City of Mississauga Department Comments

Date Finalized: 2023-05-03	File(s): A88.23 Ward: 11
To: Committee of Adjustment	
From: Committee of Adjustment Coordinator	Meeting date:2023-05-11 1:00:00 PM

Property Address: 1527 Hollywell Ave

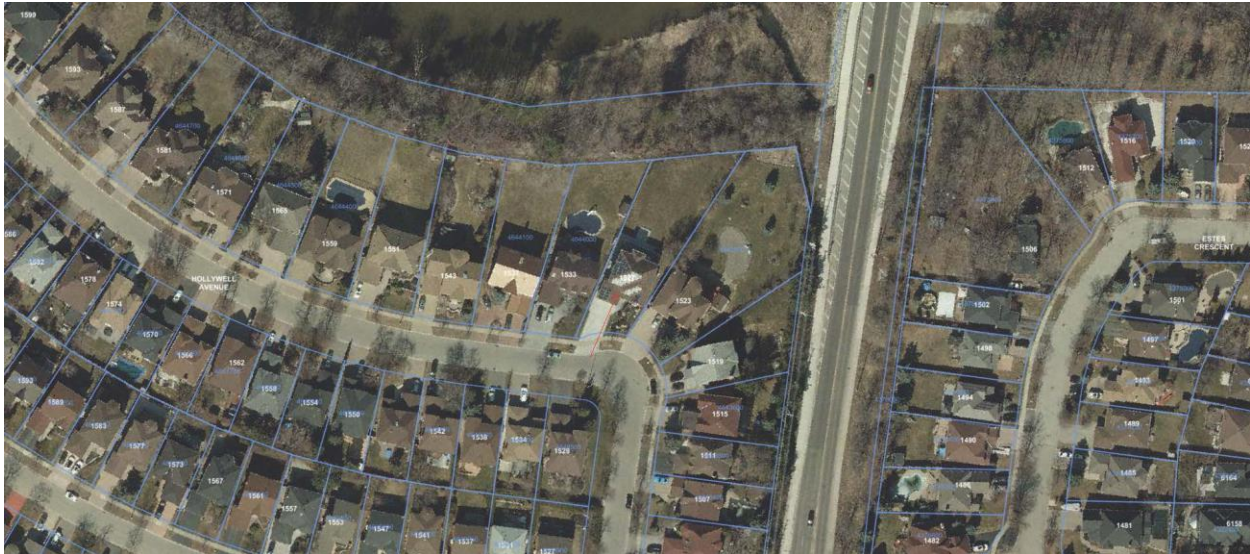
The subject property is located in the East Credit Neighbourhood Character Area and is designated Residential Low Density I and Greenlands in Schedule 10 of the Mississauga Official Plan (MOP). The shed currently under application is located on the portion of the property designated and zoned Greenlands. The Greenlands designation restricts its uses and is generally limited to recreational and infrastructure uses. The G2-3 zoning is designed to be a buffer to a natural heritage feature as well as to protect against and prevent soil erosion.

The subject property and associated hazard lands are regulated by the Credit Valley Conservation Authority, and on matters such as these Planning staff rely on the expertise of the CVC's review of the application. Credit Valley Conservation have reviewed the proposal and note objections to the proposal, calling for the shed to be removed from the hazard lands.

Given the position of CVC staff on the application and the restrictions of the Greenlands designation, Planning staff are of the opinion that the proposal does not represent appropriate development of the subject property and does not maintain the intent of the zoning by-law. Staff therefore recommend that the application be refused.
